CW OSC/AF AMP/2 TONE OSC

corrections

03 september 2003

Title: CDG2000
 Board: AF/CW OSC/2 TONE OSC Rev: A
 Author: Size: A
 Date: JAN 2003 Sheet 1 of 1

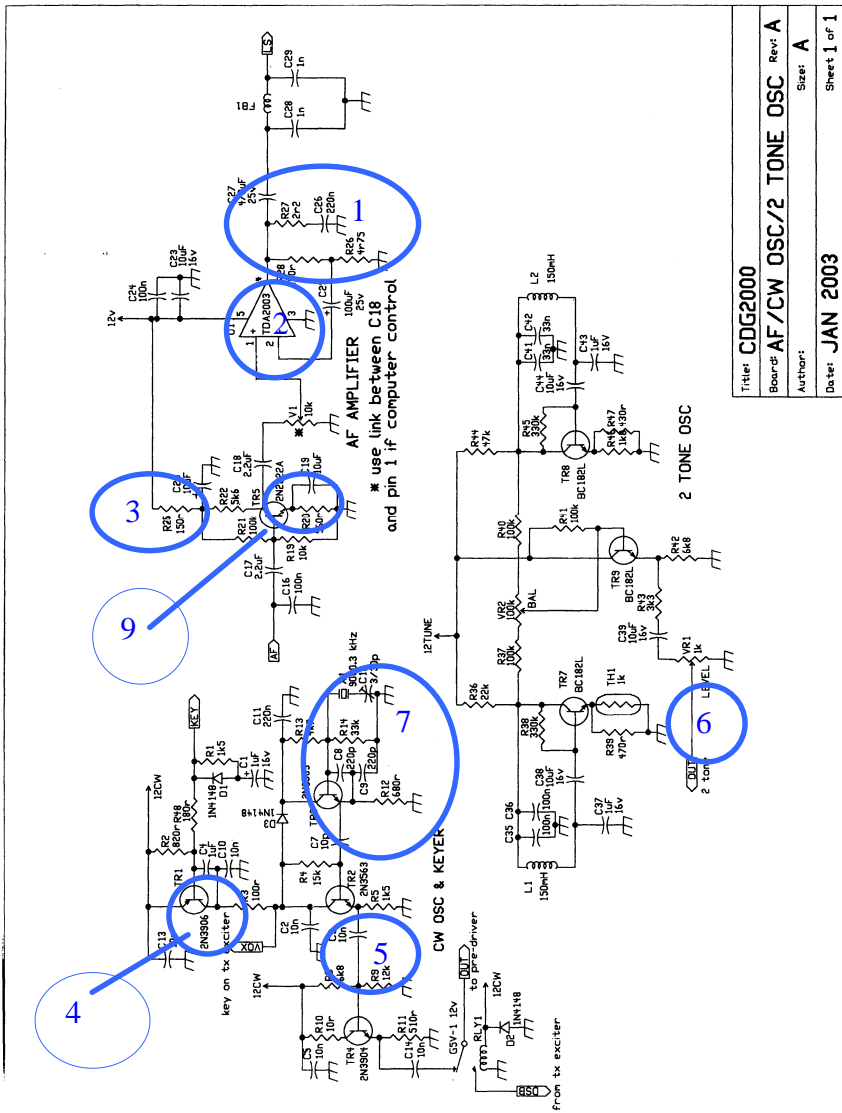
- 1** R28 is named R25 on the board and must be 1/2W, C27 is located between R28 and R27 and has plus to TDA2003 and the resistor R28 on the board (not shown on the schematic) is located between R27 and C28.

- 2** From pin 2 on TDA2003 is added a 100R in serie with a 100pF to pin 4, between pin1 and the pot V1 is C34 - 2u2 – with plus to the IC.
- 3** R25 is named R23 on the board.

- 4** The Component drawing and top overlay of TR1 is wrong. Must be turn 180 degr.
- 5** R7 is missing on the schematic – a resistor in serie with C3.
- 6** At the output of the 2tone osc. after pot VR1 is C40 (100n) – on the board and the pats list, but not on the schematic.

- 7** Xtal osc, OZ9FW has used the Osc from the tx exciter with 2N3904
- 8** C25 must be turned 180 degr. on the board.
- 9** The Produktdetektor has been modified. See the other board !!.

- 10** Remember ground at C5 and C29
- 11** Pay attention – ground in the center
